Response to Request for Additional Information (RFI) 2 Potoroo Drive Taree NSW 2430

Reference is made to DA2022/0943 for proposed Alterations and Additions to Mayo Private Hospital. Following the Hunter & Central Coast Regional Planning Panel (RRP) Briefing which was held on the 8 February 2023 and receipt of meeting minutes from the RPP, further information is requested. A further meeting to discuss options was also held on the 4th April 2023.

Figure 1 Approved Subdivision

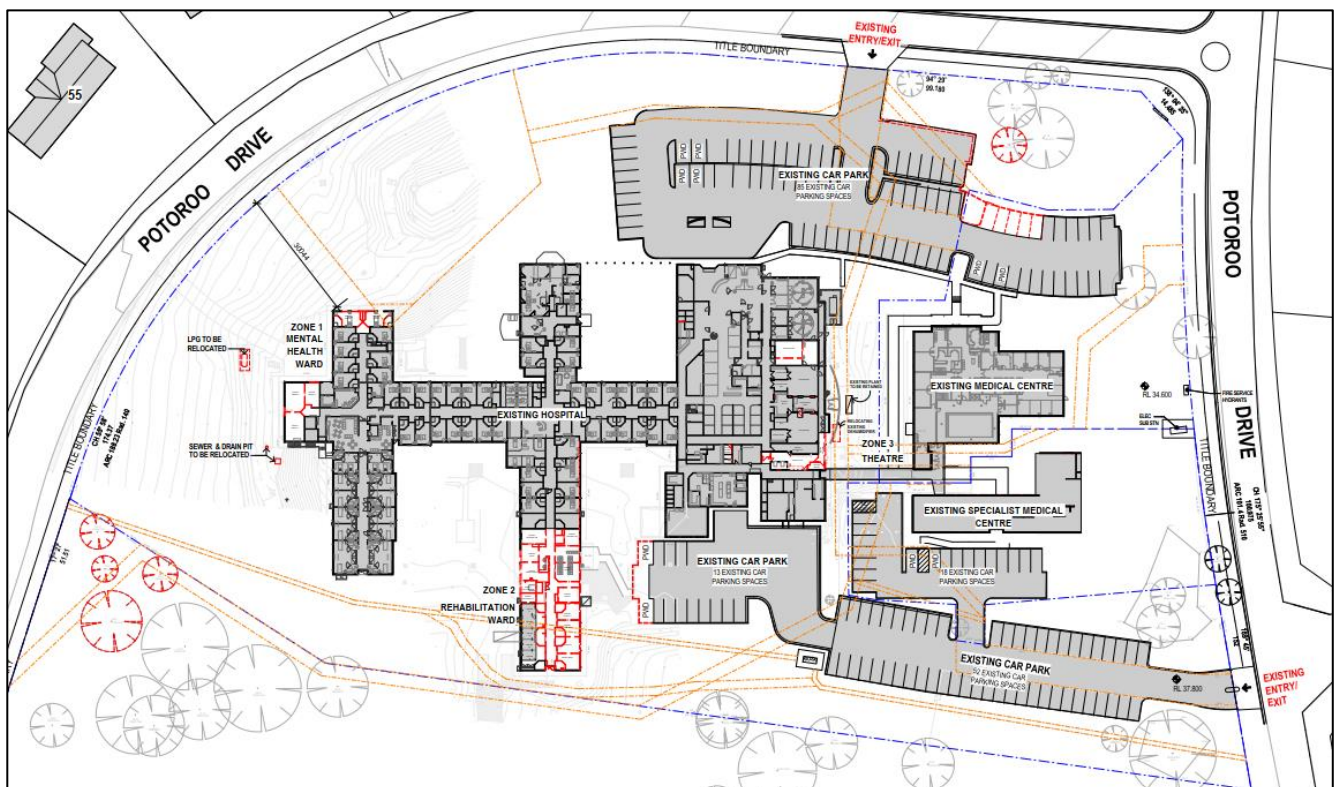
1. In relation to the existing subdivision consent the Panel want to understand the relationship between the existing approval and proposed works under this DA. Will it be surrendered, what was actually approved and whether it needs to be amended and any conditions that may or may not be relevant and impact upon the current proposal?

The approved subdivision lots have been overlaid upon the current proposed site plan, see Figure 1. The overlay clearly shows how the subdivision will create lots associated with existing buildings on the site. No alterations to the subdivision will be required as a result of the proposed development.

Figure 4 Proposed Landscaping within front setback

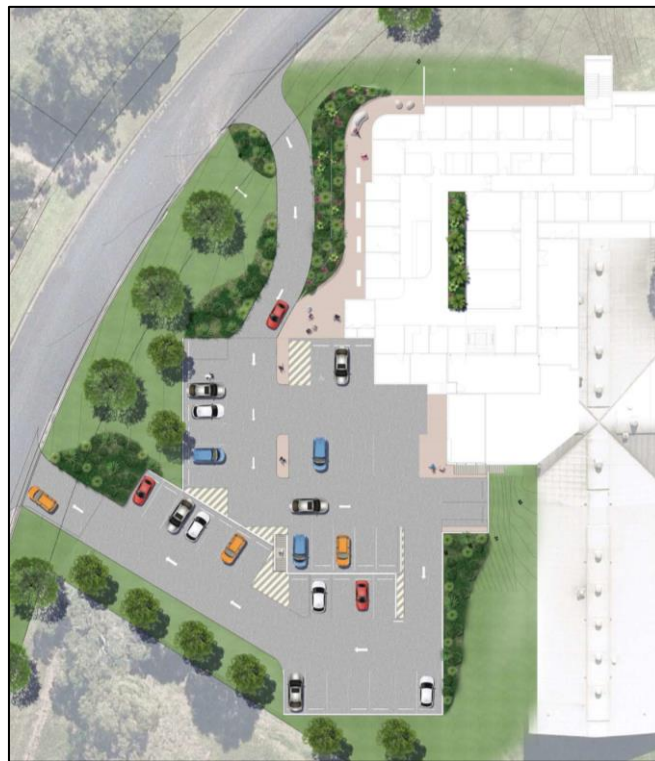
3. The Panel noted the proposed setback to the street of 2.7m and questioned the appropriateness of this in a semi-rural area.

Figure 4 provides an overview of the amended front setback presentation. Refer to Appendix A for amended Architectural Plans and Appendix C for amended Landscape Plans.

Figure 7 Comparison of Retaining Walls – Lodgement and Amended Designs

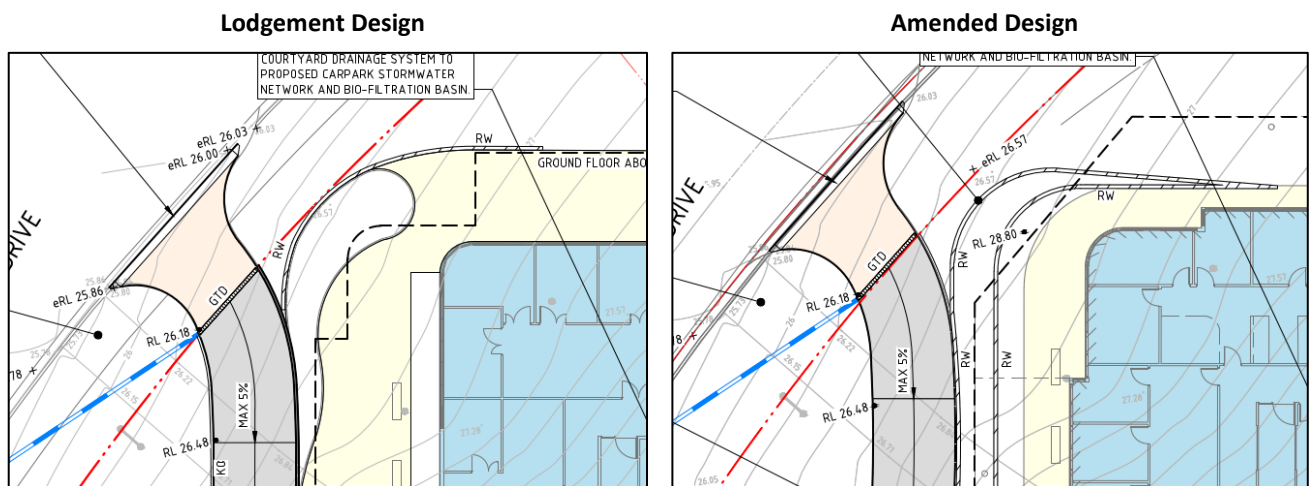
2. The interface between the development, the streetscape and the surrounding rural residential houses needs to be understood. The location of the car parking and any proposed landscaping on the site will be important and this needs to be demonstrated through the provision of detailed cross sections.

In addition to the building elements forward of the building, notably the retaining wall and car parking, were raised as a concern in terms of the visual impact of the built form to the street. The original design included a retaining wall at the frontage, being circa 2 metres high. The revised design has tiered retaining, and achieved a setback to the bottom tier of 1.2 metres. This has significantly reduced the visual impact of the retaining, the stepped retaining walls are provided at 1.2m, 3.1m, and 4.8m setbacks from the boundary with landscaping proposed within planting beds at each step. Refer to **Figure 7** for comparison of the retaining wall at lodgement and the amended design.

Figure 9 Car Park Presentation

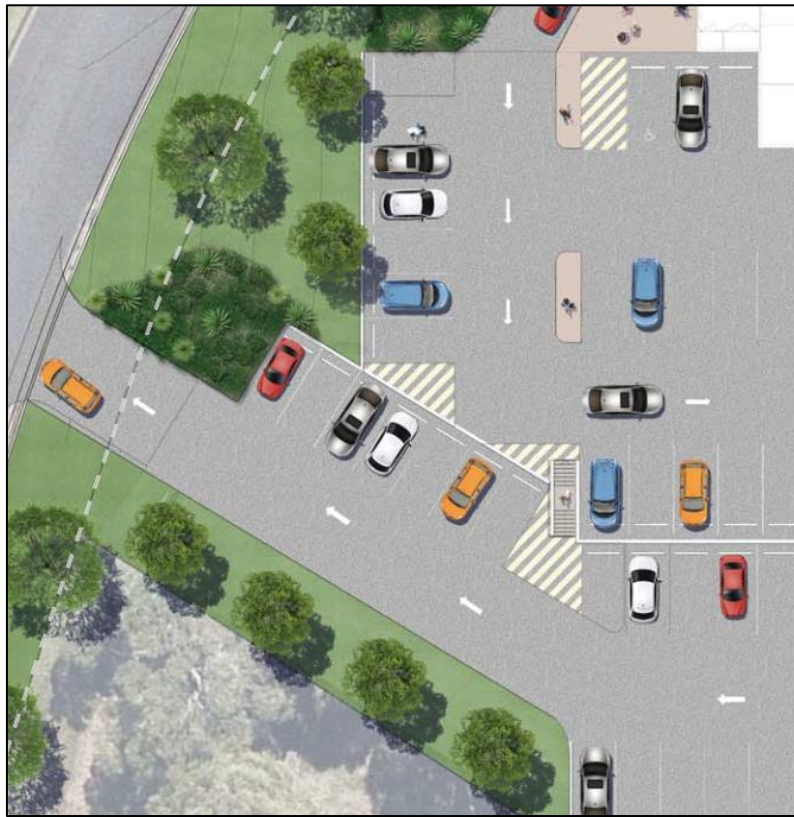
4. The Panel will consider the proposed development in relation to the context and balance of the site – particularly the interface with the carpark and what is proposed as the balance of the site under current approvals.

Further setbacks have been provided for the car park interface with the street. The two parks closest to the boundary at the exit crossover have been removed and replaced with landscaping improving interface whilst the row of car parking adjoining the southern boundary of the hospital have been moved. This facilitates additional landscaping to provide a level of screening and integration of the development with the surrounding area. These changes to the car park have been undertaken in direct response to input received from the 4 April 2023 meeting discussing options and outcomes.

The amended landscaping utilises a mix of street trees and boundary planting to provide a forward screen to elevated elements. Lower laying plantings are proposed around the retaining walls within the car park area to provide a level of integration of the hard elements into the presentation. Figure 4 and 9 shows the amendments and treatment of the proposed car park and exit crossover.
